# Access Compliance Report

## Public Rights-of-Way

### (Curb Ramps)

Intersection ID: 10029830		Main Street: KREFELD_DR		Cross Street: N/A		Location:		NW			
ADA ID: C11F0C7ED37C		Ramp Type: Directional1		Initial Pass/Fail: Pass		Overall Compliance: No		Severity Score: 0			
Codes/Mitigation Info/Possible Solution				Field Measurements/Component Compliance							
				Possible Solutions:		Compliance		Description		Data	
				Remove & Replace Entire Ramp. Remove & Replace Gutter.		N/A		Ramp Length (in)		0.0	
<p>Surveyor Notes:</p> <p>DEBRIS COVERING RAMP</p>						N/A		Ramp Width (in)		0.0	
						N/A		Ramp Slope (%)		0.0	
						N/A		Ramp XSlope (%)		0.0	
						N/A		Flare Type LT		N/A	
						N/A		Flare Slope LT (%)		N/A	
						N/A		Flare Traversable LT?		N/A	
				No		Landing Length (in)		0.0		N/A	
				No		Landing Width (in)		0.0		N/A	
				No		Landing Slope (%)		0.0		N/A	
				No		Landing X Slope (%)		0.0		N/A	
PROW/ADA:				N/A		Landing Curb? (Y/N)		N/A		N/A	
				N/A		Shared Landing?		N/A		N/A

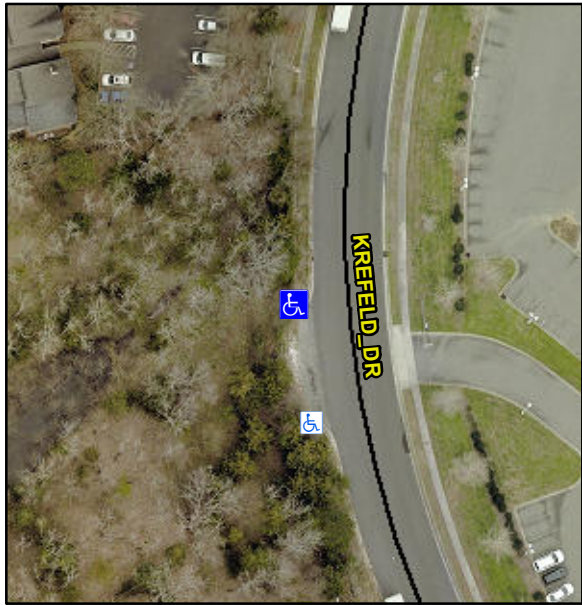
R304.2.1, R304.2.2-Perp, R304.3.2-Para, R304.5.3, R302.7.2, R304.5.4				Yes		Gutter Ponding?		0.0		No	
				No		Gutter Lip Ht (in)		0.0		No	
				N/A		Painted X Walk1?		N/A		Road Slope (%)	
						X Walk 1 Direction		N/A		Road X Slope (%)	
						X Walk 1 Width (in)		0.0		Clear Space?	
						X Walk 1 Slope (%)		0.0		N/A	
						X Walk 1 X Slope (%)		0.0		Yes	
				N/A		Ramp inside XWalk1?		N/A		Storm Grate/Utility Type	
				Yes		Any Obstructions?		N/A		N/A	
						Obstruction Type		N/A		N/A	
								N/A		Surface Condition? (G/P)	
								N/A		N/A	
Total Cost:				\$		2350.00
